Access Compliance Report

Public Rights-of-Way

(Curb Ramps)

Intersection ID: 42401	Main Street: GRIERS GROVE RD	Cross Street: MCALLISTER DR	Location: SE
ADA ID: 79522730D6FD	Ramp Type: PerpDiag	Initial Pass/Fail: Fail	Overall Compliance: No
Severity Score: 47.5			
Codes/Mitigation Info/Possible Solution		Field Measurements/Component Compliance

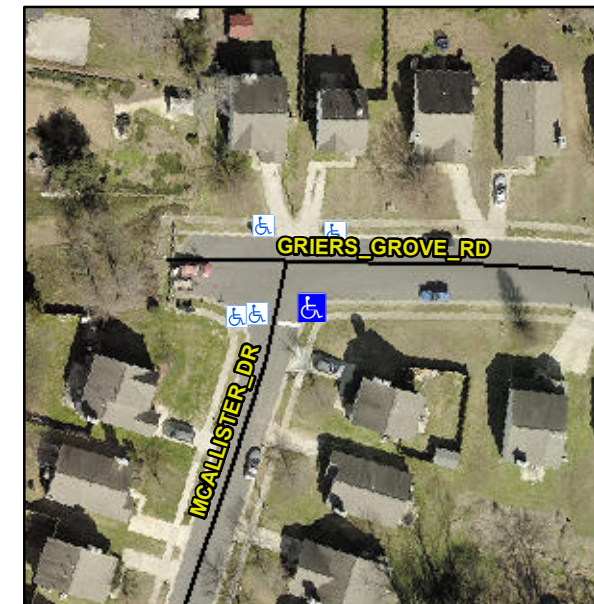
Not Found, R304.5.1, R304.2.2

Compliance	Description	Data	Compliance	Description	Data
N/A	Ramp Length (in)	57.0	No	Ramp Slope (%)	8.4
No	Ramp Width (in)	30.0	Yes	Ramp XSlope (%)	1.5
N/A	Flare Type LT	N/A	N/A	Flare Type RT	N/A
N/A	Flare Slope LT (%)	N/A	N/A	Flare Slope RT (%)	N/A
N/A	Flare Traversable LT?	N/A	N/A	Flare Traversable RT?	N/A
N/A	Landing Length (in)	N/A	N/A	DWS Provided?	N/A
N/A	Landing Width (in)	N/A	N/A	DWS Contrast?	N/A
N/A	Landing Slope (%)	N/A	N/A	DWS Length (in)	N/A
N/A	Landing X Slope (%)	N/A	N/A	DWS Full Width?	N/A
N/A	Landing Curb? (Y/N)	N/A	N/A	DWS Offset (in)	N/A
N/A	Shared Landing?	N/A			
N/A	Gutter Ponding?	N/A	N/A	Gutter Slope (%)	N/A
N/A	Gutter Lip Ht (in)	N/A	N/A	Gutter X Slope (%)	N/A
N/A	Painted X Walk1?	No	N/A	Painted X Walk2?	No
	X Walk 1 Direction	To W		X Walk 2 Direction	To N
N/A	X Walk 1 Width (in)	N/A	N/A	X Walk 2 Width (in)	N/A
	X Walk 1 Slope (%)	2.2		X Walk 2 Slope (%)	1.1
	X Walk 1 X Slope (%)	0.1		X Walk 2 X Slope (%)	3.1

Remove & Replace Curb Ramp With Two New Directional Ramps or Equivalent.
